Evidence ET-1:

Charlotte Avenue Distance Measurements

LAND AT ELMSBROOK, BICESTER: PROPOSED RESIDENTIAL DEVELOPMENT

Planning Inspectorate Ref.No. APP/C3105/W/23/3315849

Figure 1-1: Diagram from VTP ‘Spine Road Assessment’ plan, showing proposed road capacity scheme modifications for this section of Charlotte Avenue, just north of Gagle Brook School.

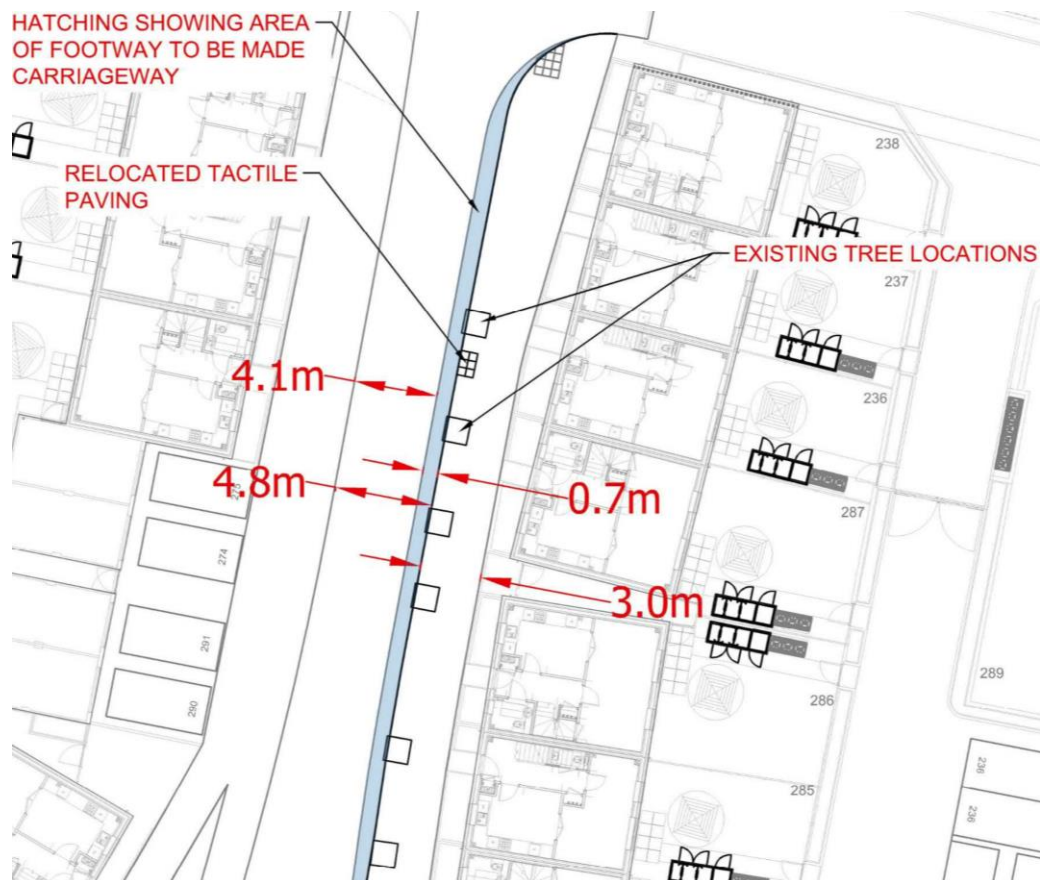
- 1.1 VTP’s “Elmsbrook Spine Road Assessment, Rev A” (“4600-1100-T-073-A - Elmsbrook Spine Road Assessment.pdf”) provides the diagram shown in part below in Figure 1-1; however:

- 1.2 The tree base overlaps, i.e. where the blue hatched area below cuts through the square boxes referred to as “Existing Tree Locations”; thus the 0.7 metre increase required is going to cut into these root areas, which are 0.5 metres from the kerb edge as shown in Figure 1-3. Therefore, the diagram is correct and if the road width is extended the trees would need to be removed. This is not allowable under the Tree Policy for Oxfordshire, Policy 11.

- 1.3 The 3.0m width shown lies underneath the outward spread of the trees (see Figure 1-2); this does not provide enough height for cyclists to pass under, according to DMRB CD 195; again, the trees would thus need to be removed if the road is widened, which is not allowable.

- 1.4 The 3.0m measurement is shown by VTP regarding their argument that 3.0m is the minimum required by CD-195 for this combined cyclist and pedestrian path – however, this is incorrect: as can be seen on Figure 1-2, the eastern border of the 3.0m shown is a fence along the front of the adjacent properties. This fence is over 600 mm tall, so the minimum combined path width according to CD-195 Table E/3.2 is increased to 3.5m. Such a width cannot be fitted between the proposed modified road edge and adjacent property boundaries.

- 1.5 There are also impingements on the pavement reducing its width to under 3.0 m, where the bus stop and cycle parking facilities are located, slightly further down.

Figure 2-1: VTP diagram showing proposed modifications to the Charlotte Avenue bridge between Phase 1 and Phase 2, to the east of Gagle Brook School.

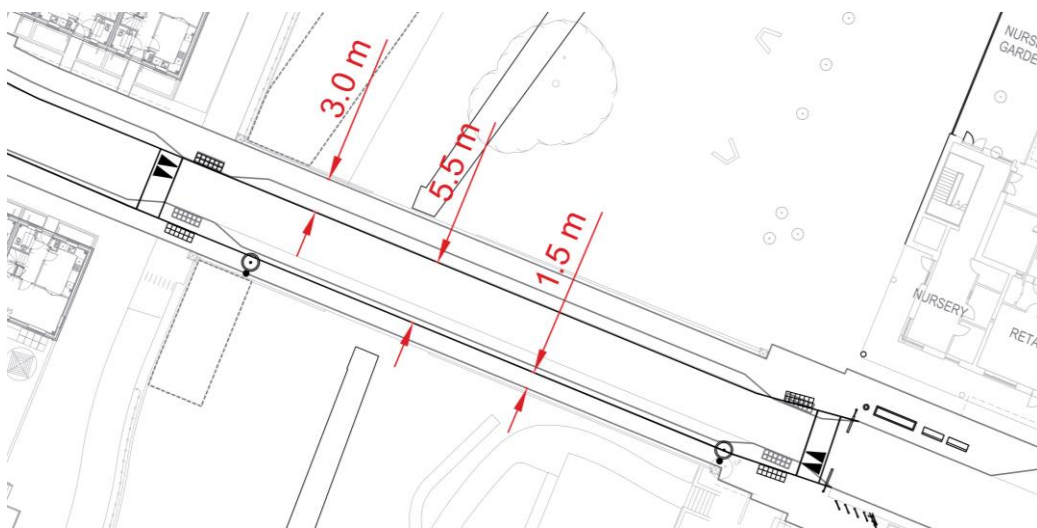
- 2.1 VTP's "Bridge Footway Provision, Rev A" ("4600-1100-T-029-A - Bridge Footway Provision.pdf") provides the diagram shown in part below in Figure 2-1; however, the measurements shown are both incorrect and not physically possible. This is because:

- 2.2 As per section A of this document: the bridge parapets are more than 600 mm tall, so DMRB CD-195 requires 3.5 metres width for a combined cycle/foot path, not 3.0 metres.

- 2.3 Similarly, the minimum pavement width for walking only, for this type of road, is 2.0 metres, not 1.5 metres.
- 2.4 The proposed design suggests 1.5 m + 5.5 m (road) + 3.0 m = 10.0 metres total width; however, both bridges on Charlotte Avenue have been constructed with between-wall distances of 9.6 metres between the top stones, and thus ~9.7 metres between the (uneven) Beckstone block walls. Example laser rangefinder measurements for each bridge are shown in Figures 2-2 and 2-4.

- 2.5 The minimum requirement for street width here is 4.8 metres – so the VTP diagram appears to show that this can easily be achieved (with 0.7 metres to spare); however, due to the errors on the diagram in both measurement fit and CD-195 requirements, the true available road width would be calculated as 9.7 m – 3.5 m – 2.0 m = 4.2 metres; which is 0.6 metres **below** the required minimum.

Figure 2-2: Laser measurement of mid-Phase 2 bridge: shown to be 9.614 metres between walls

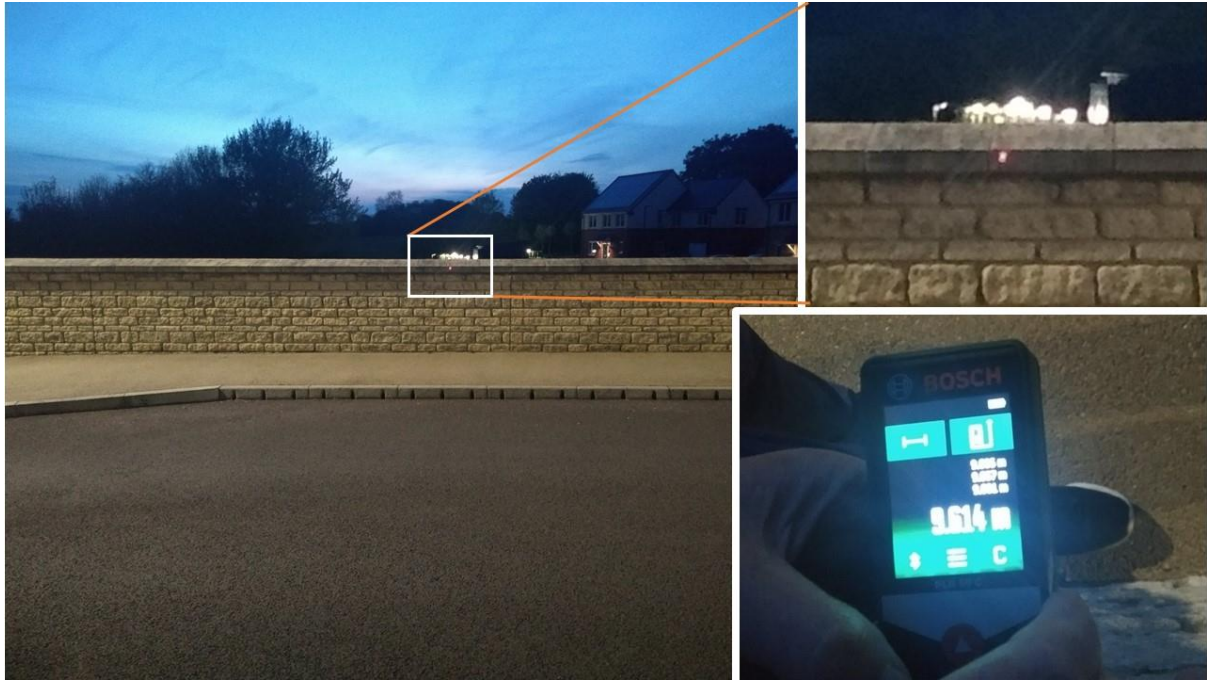
- 2.6 The proposed design also requires removal of the build-out road narrowings at each end of both bridges, shown in Figures 2-3 and 2-5. These are 4.0 metres between kerbs, thus well below the 4.8 metre minimum required for car/bus passage, and thus render the traffic one-way flow here. They are also accompanied by bollards. These are design features to show they are crossings for pedestrians and cyclists. The bridge shown in Figure 2-1 is next to the Phase 1 park (south of it), and further park/woodland (north of it). The other bridge is next to the Forest School entrance, and is where pupils walking to school from Phases 2, 3 and 4 would safely cross the road on their way to school (NB: this is because there is no footpath on the school side of the road further along). Removing them therefore *reduces* the safety for pupils and other pedestrians crossing at these points.
